NOTICE OF MEETING

Planning and Environment Committee Meeting No. 4/13

Item		Page
1	CONFIRMATION OF MINUTES - Meeting held on 5 March 2013	1
2	6 GANORA STREET, GLADESVILLE. LOT 6 DP 27608. Local Development Application for alterations and first floor addition to dwelling. LDA2012/0426. <i>INTERVIEW 5.00PM</i>	7
3	20 BEATRICE STREET, NORTH RYDE. LOT 73, DP 36618. Local Development Application for a new two storey dwelling. LDA2012/0408. <i>INTERVIEW 5.05PM</i>	43
4	62 DARVALL ROAD EASTWOOD. LOT 11 DP 6247. Local Development Application for demolition of the existing dwelling and erection of an attached dual occupancy. LDA2011/380. <i>INTERVIEW 5.10PM</i>	86

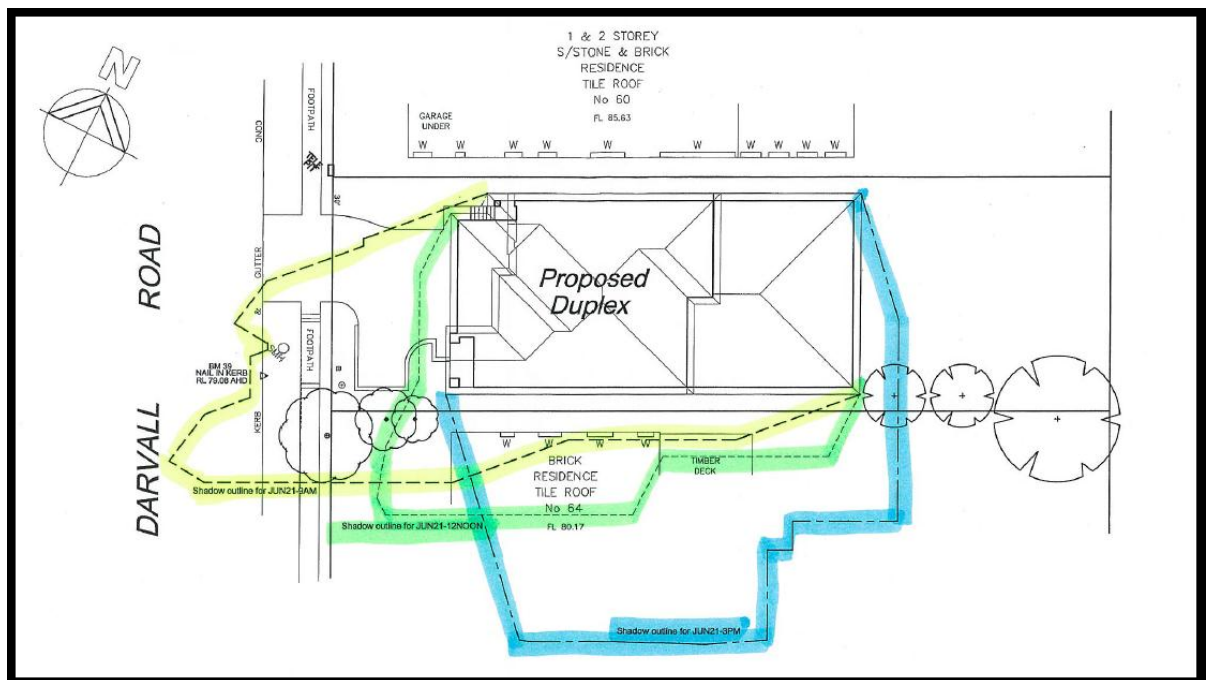
5. Solar Access (for neighbouring properties): DCP 2010 states that for neighbouring properties, the windows to north-facing living areas of neighbouring properties must receive at least 3 hours of sunlight between 9am and 3pm on 21 June over a portion of their surface, where this can be reasonably maintained given the orientation and topography of the subject and neighbouring sites.

The proposed development would result in less than three (3) hours sunlight being available for the north-facing living room windows at No 64 Darvall Road and therefore does not comply with this requirement.

Comment: As noted in the previous report to the Planning & Environment Committee, solar access is difficult to protect for No 64 Darvall (which is both due south and down hill from the subject site).

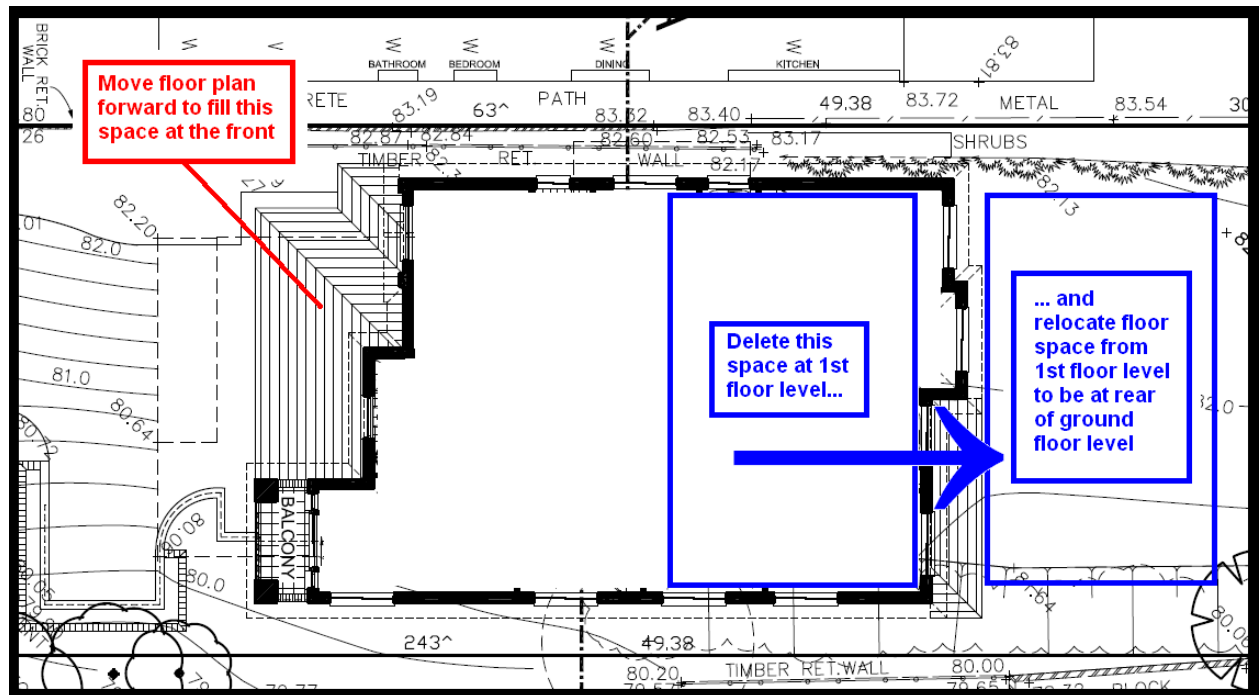
for this development are summarised below and shown in the marked-up plan below:

- Re-design the 1st floor level to move the floor plan forward to “fill” the space at the front of the dwelling; and/or
- Remove the rear portion of the 1st floor and/or extend the ground floor level towards the rear.

These design solutions have been suggested to the applicant on several occasions in meetings with Council officers during the processing of the application, but they have declined to make the requested amendments. The applicant has indicated that this is a “standard” design obtained from the housing company and any variations would incur a financial cost, and instead of amending the design to accommodate view sharing, the applicant has chosen only to justify the current design via a written submission.

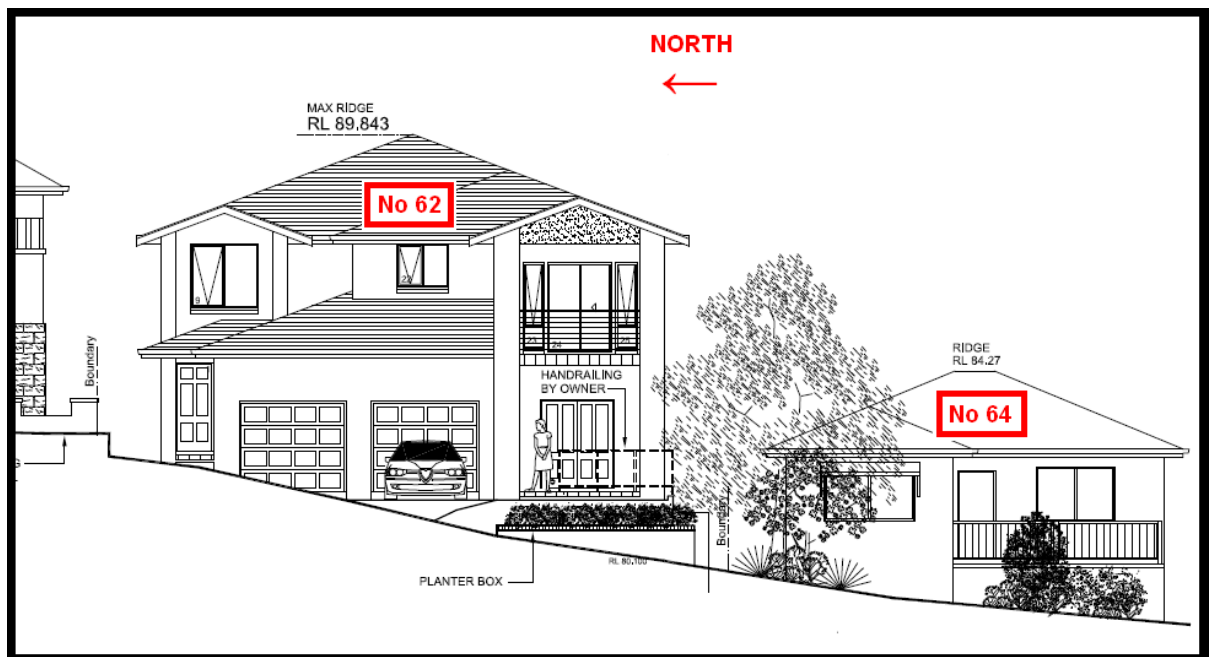
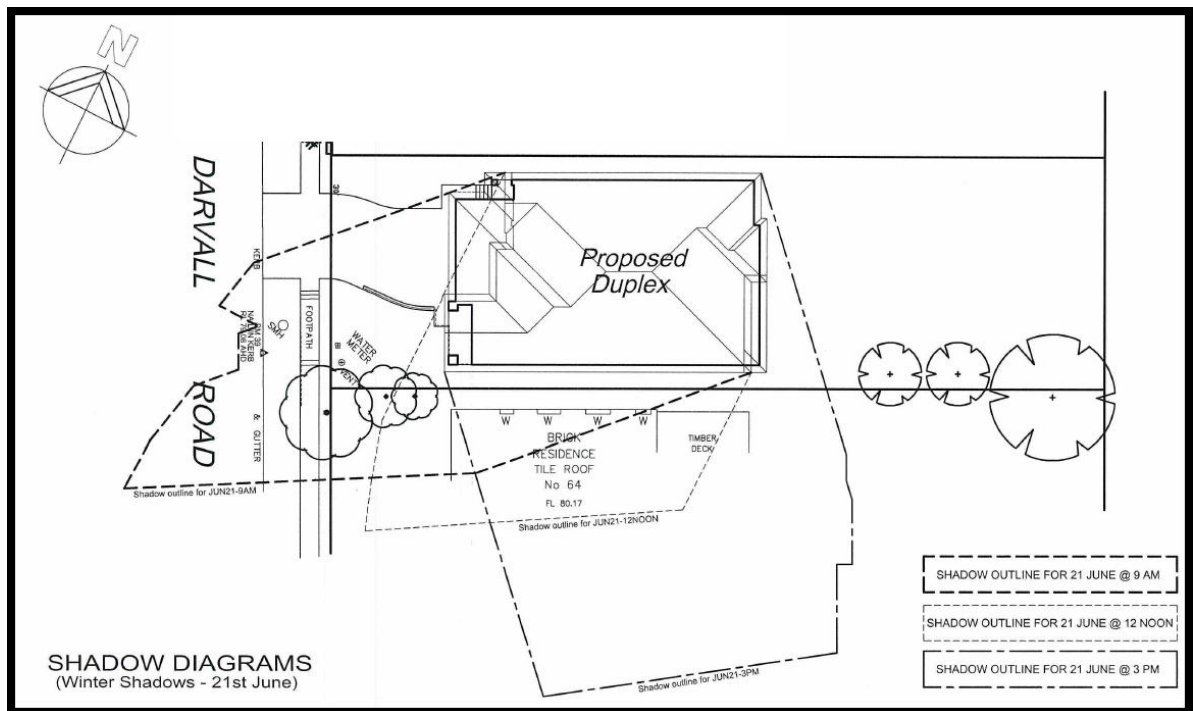
- 4. Overshadowing of No 64 Darvall Road.** *Concern is raised that the proposal would have excessive overshadowing impacts on this adjoining property. A more sensitive design should be chosen which would improve solar access.*

Comment: It is considered that the topography and orientation of the subject and neighbouring sites means that any development (even a single storey dwelling) would cause significant overshadowing on No 64 Darvall – which is both due south and significantly lower than No 62. However, these impacts are exacerbated by the design proposed in this application, which is a full-length 2 storey building. As with issues regarding view impacts, it is agreed that a more sympathetic design could at least minimise overshadowing impacts on No 64 to a reasonable level, however the design chosen in this application would cause severe overshadowing as well as general impacts of bulk, scale and massing and is unacceptable. The following is a streetscape drawing showing the proposed development relative to No 64 to the south, as well as the shadow diagrams submitted for this DA:
